SITE DEVELOPMENT PLAN
VASA PALMER PARK
HD POWERS LLC
PPRXXXX

LANDSCAPE PLAN

L1.0
Sheet 3 of 5

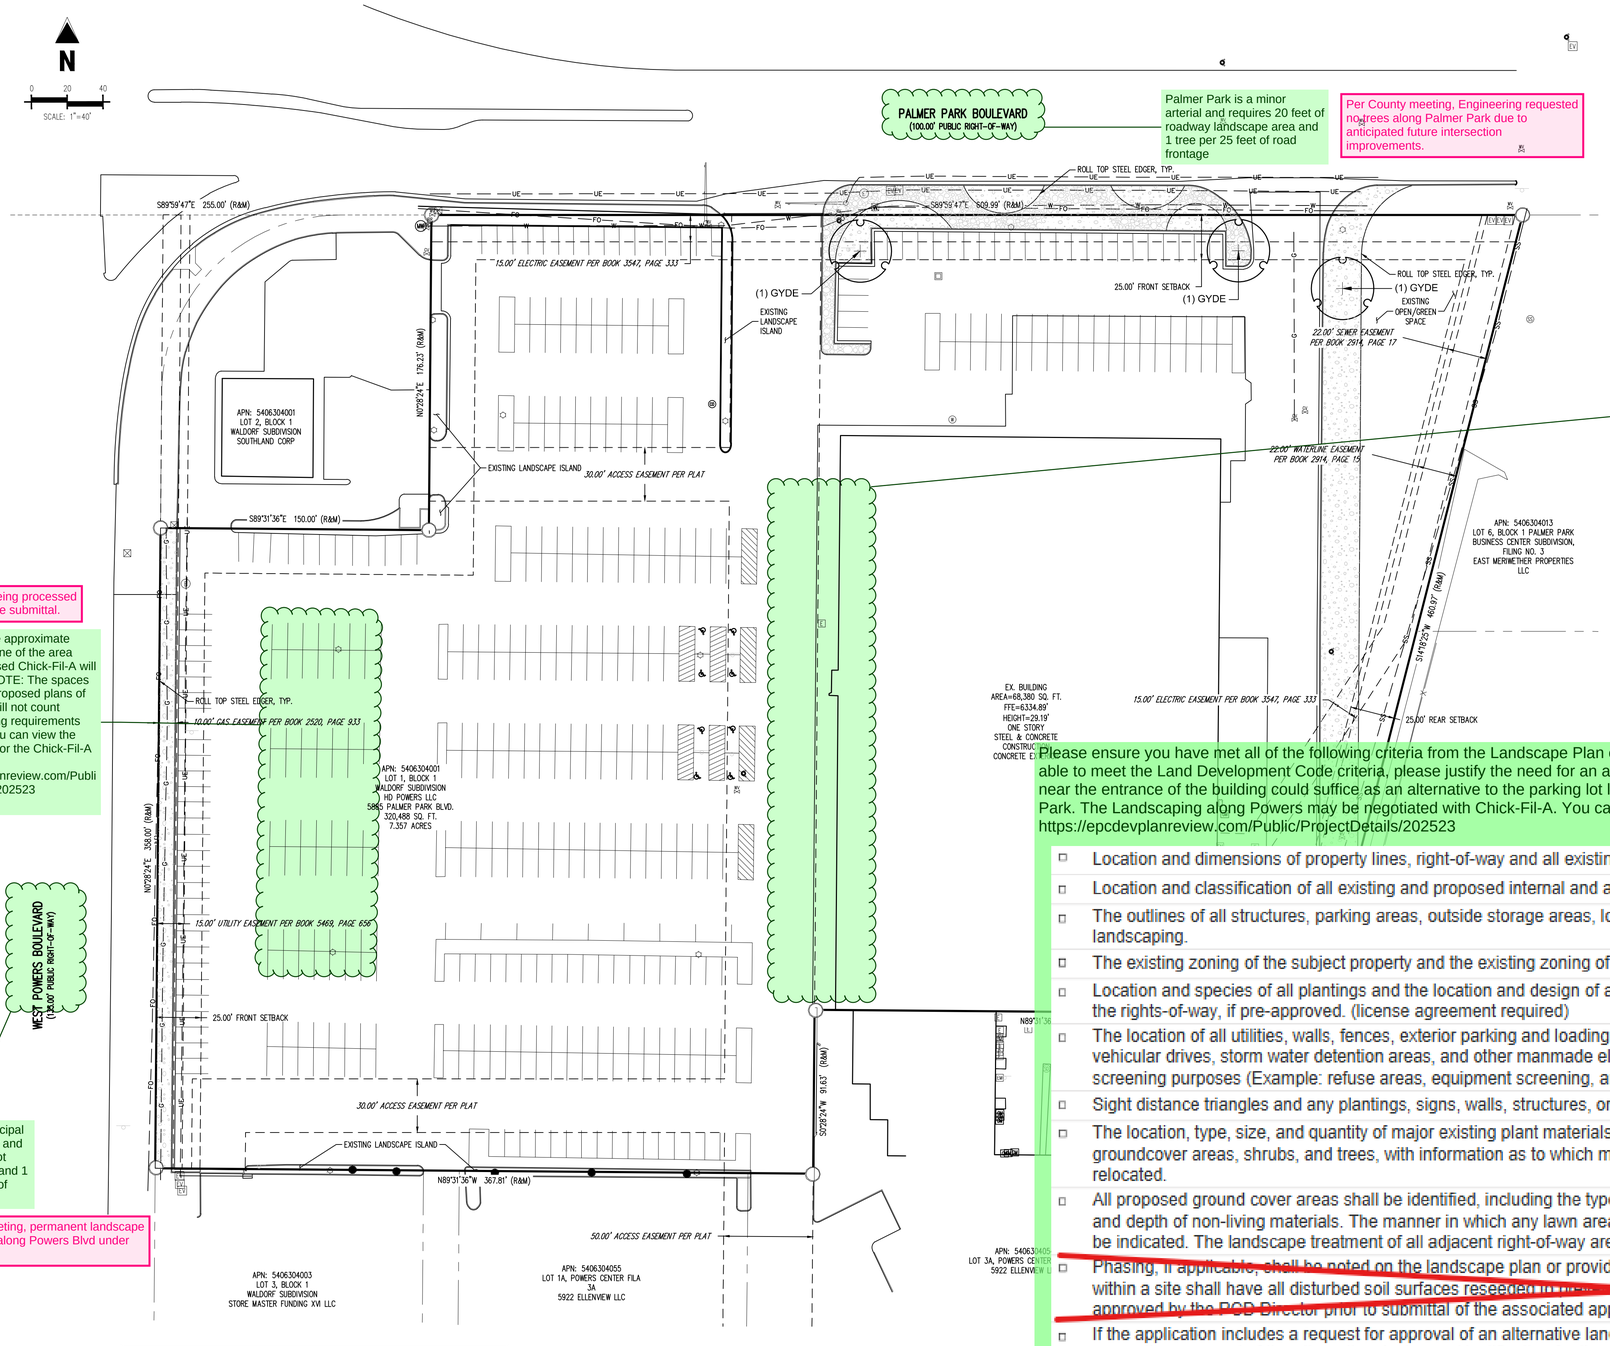
Palmer Park is a minor arterial and requires 20 feet of roadway landscape area and 1 tree per 25 feet of road frontage

FYI:
Plantings near the front entrance of the building were discussed as a possible alternative solution to landscaping

Please depict the approximate location and outline of the area where the proposed Chick-Fil-A will be developed. NOTE: The spaces covered by the proposed plans of the Chick-Fil-A will not count toward the parking requirements for the VASA. You can view the submitted plans for the Chick-Fil-A at this link: https://epcdevplanreview.com/Public/ProjectDetails/202523

Powers is a Principal Arterial roadway and requires a 25 foot landscape area and 1 tree per 20 feet of road frontage

Please ensure you have met all of the following criteria from the Landscape Plan checklist below as well as Section 6.2.2. in the Land Development Code. If you are not able to meet the Land Development Code criteria, please justify the need for an alternative landscape plan. As discussed in the meeting at the end of last year, plantings near the entrance of the building could suffice as an alternative to the parking lot landscaping requirements and beefing up the roadway landscaping a bit along Palmer Park. The Landscaping along Powers may be negotiated with Chick-Fil-A. You can view their proposed plans at this link: https://epcdevplanreview.com/Public/ProjectDetails/202523

Please include Page 2 (included with Site Development Plan) with this standalone Landscape Plan

Per County meeting, Engineering requested no trees along Palmer Park due to anticipated future intersection improvements.

Annual planters have been added to the front of the building.

Chick-Fil-A is being processed under a separate submittal.

Per County meeting, permanent landscape is not required along Powers Blvd under this submittal.

Title of sheet revised to "Alternative Landscape Plan" and justification has been added to the LOI.

Annual planters have been added to the front of the building.
